ADDENDUM # 4

Project	TA Blakelock High School Renovations	Project No.	2215-C
Location	1160 Rebecca Street, Oakville, ON	Date of Issue	2025 05 02
Owner	Halton District School Board	File	2215/7.1.3

This Addendum forms part of the Contract Documents and amends the original Drawings and Specifications, dated 2025 04 17, and all preceding Addenda, as noted below.

PART GROUND FLOOR FRAMING PLAN
SCALE: 1:100

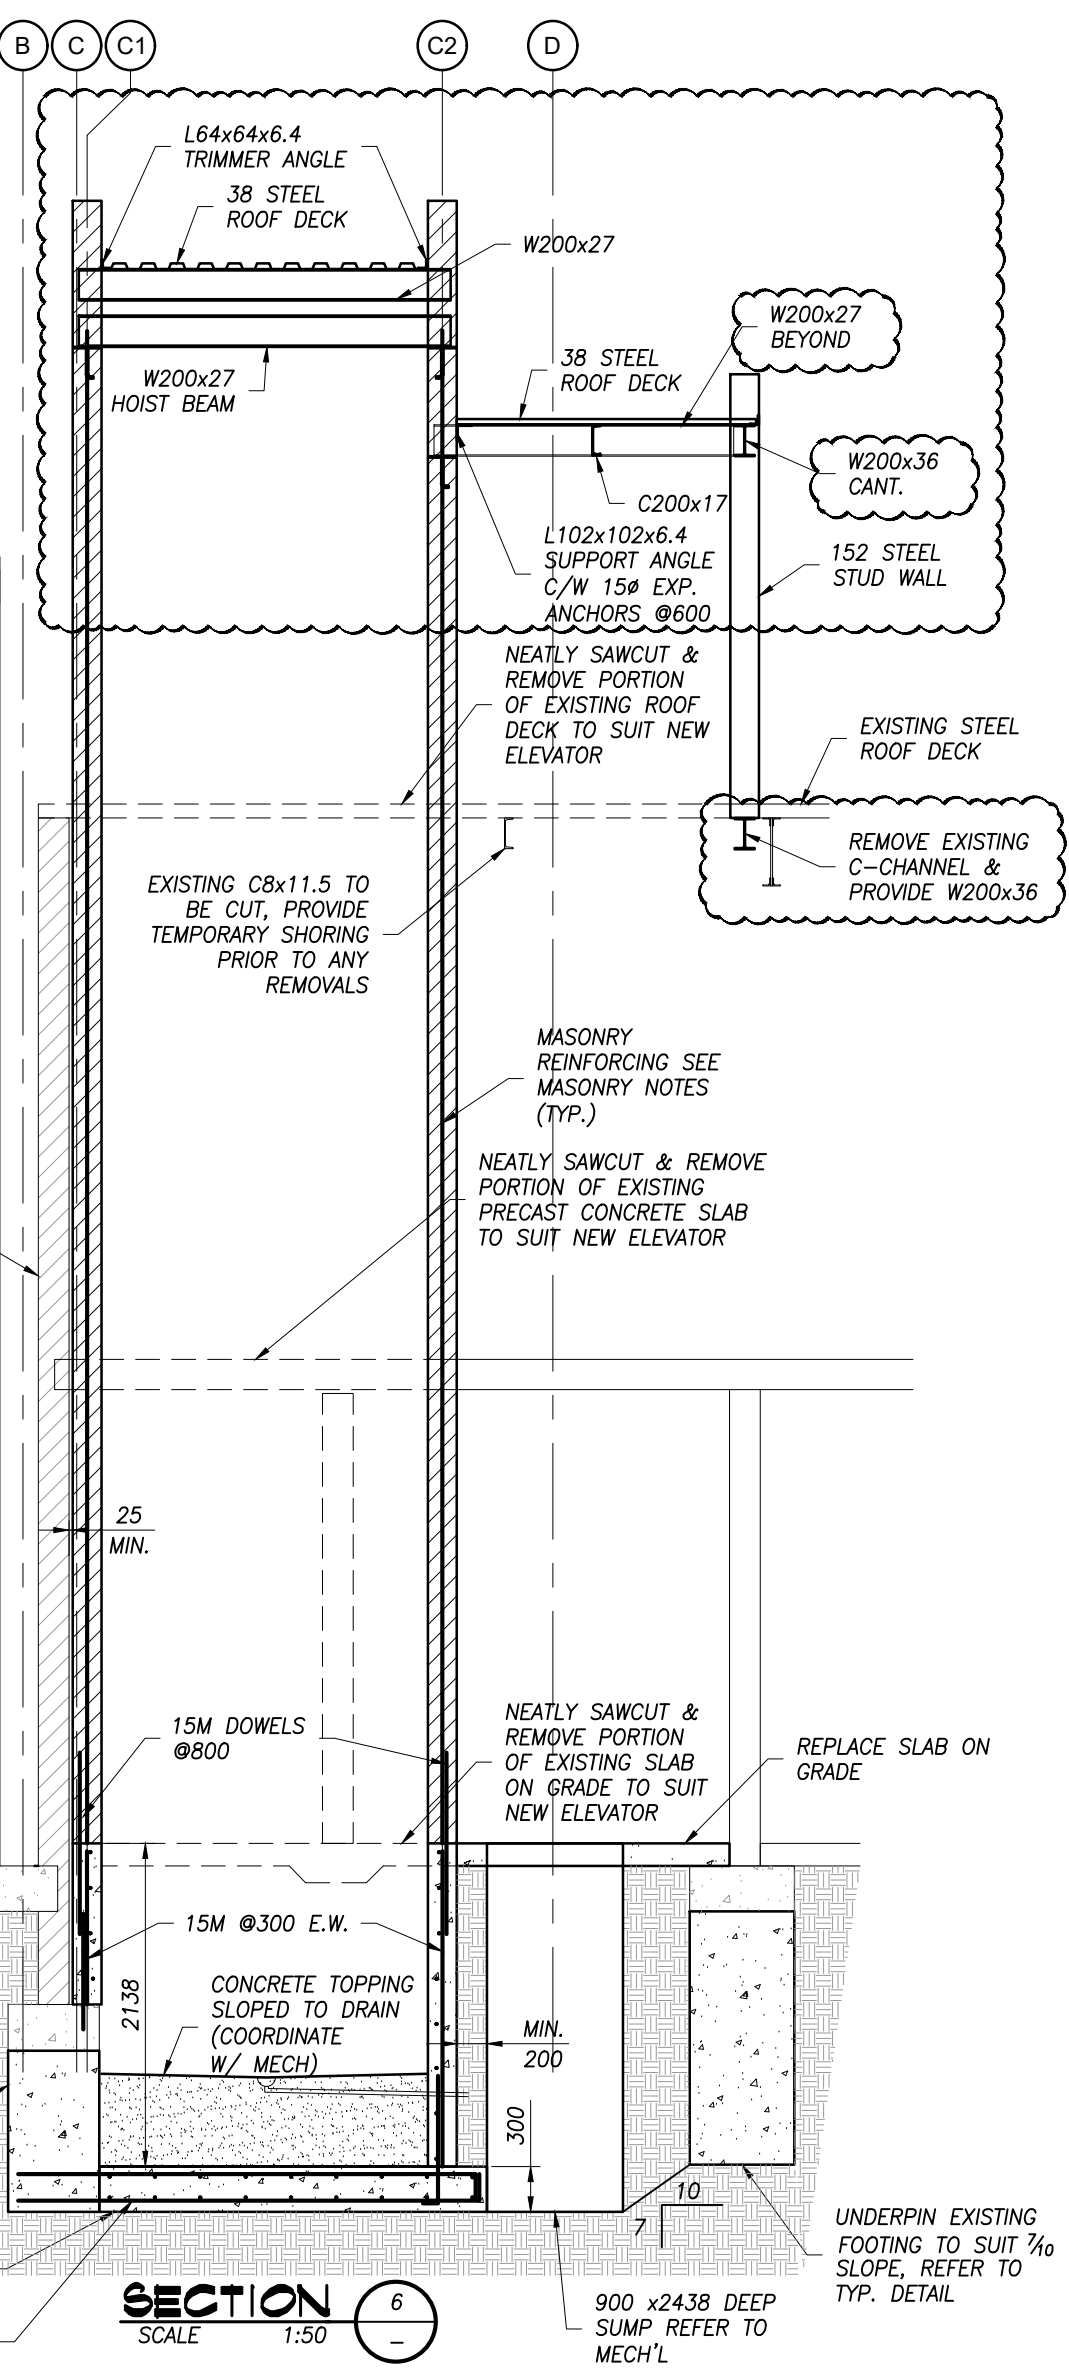
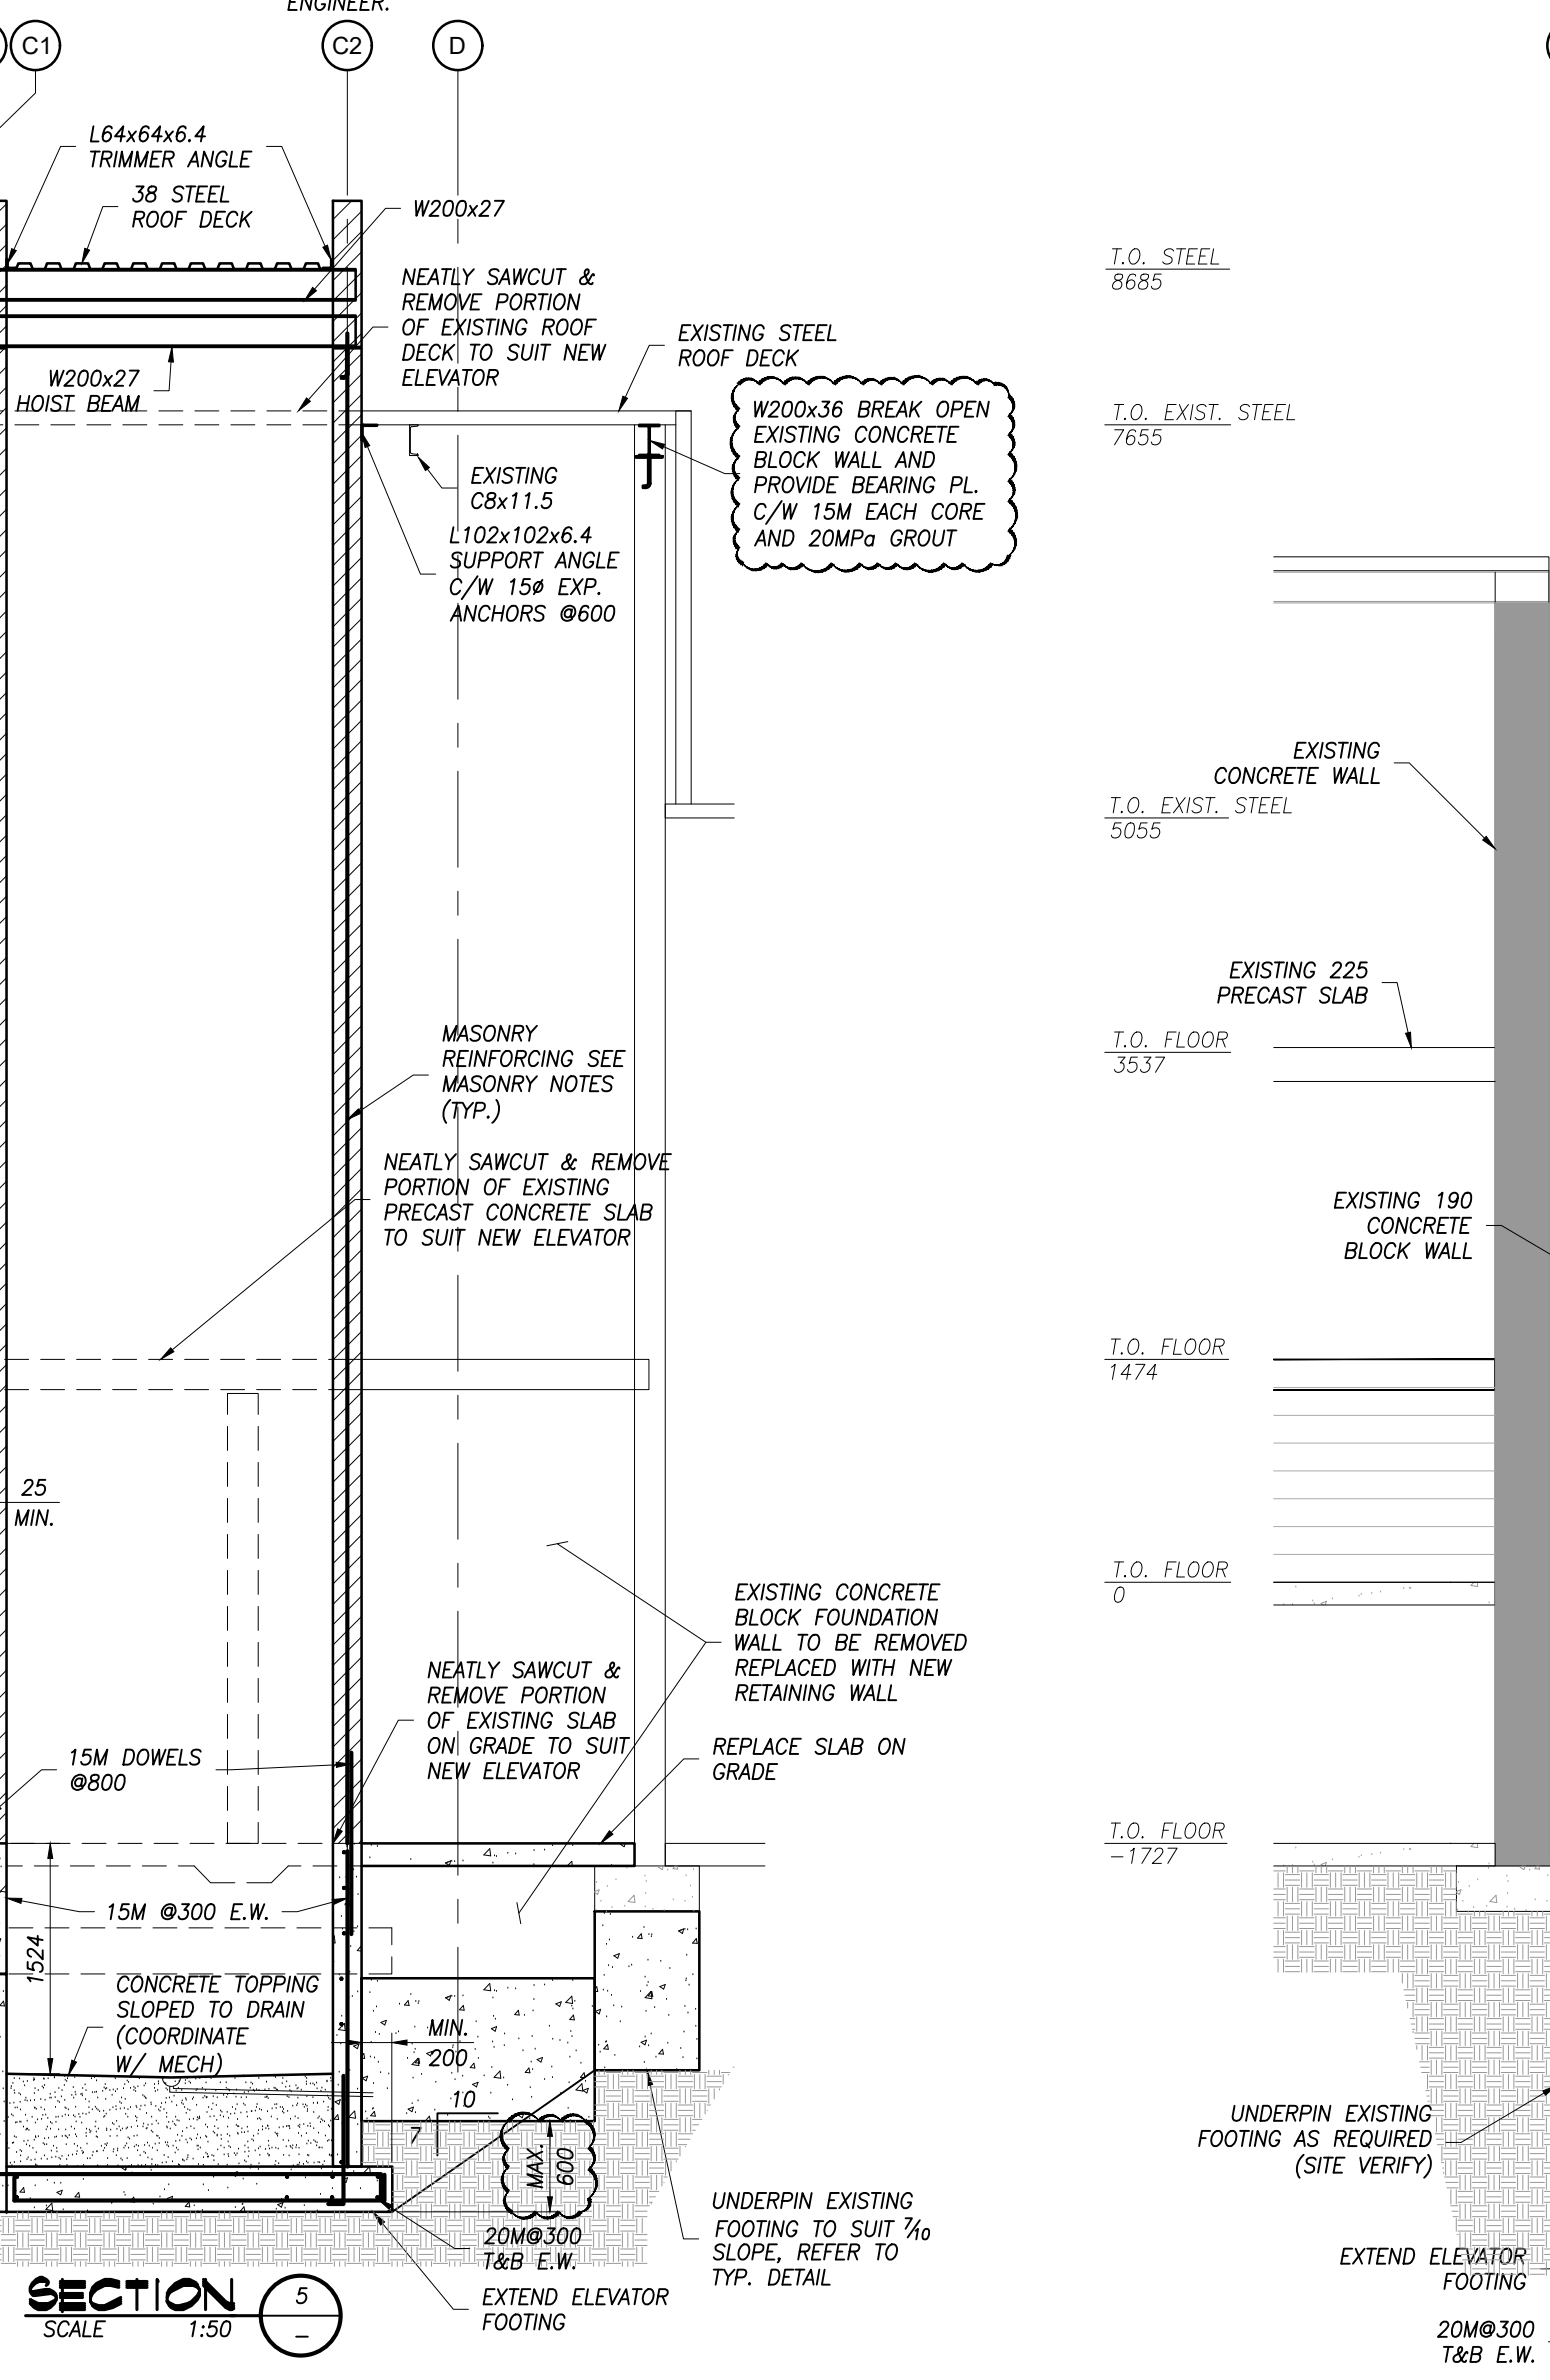
- A. Drawing S000:
 - a. General Steel Deck notes added to the drawing.
- B. Drawing S100:
 - a. Extent of grouting existing foundation wall for new column clarified.
- C. Drawing S200:
 - a. West Elevator framing updated to match architectural sections.
- D. Drawing S300:
 - a. East Elevator framing updated to match architectural sections.
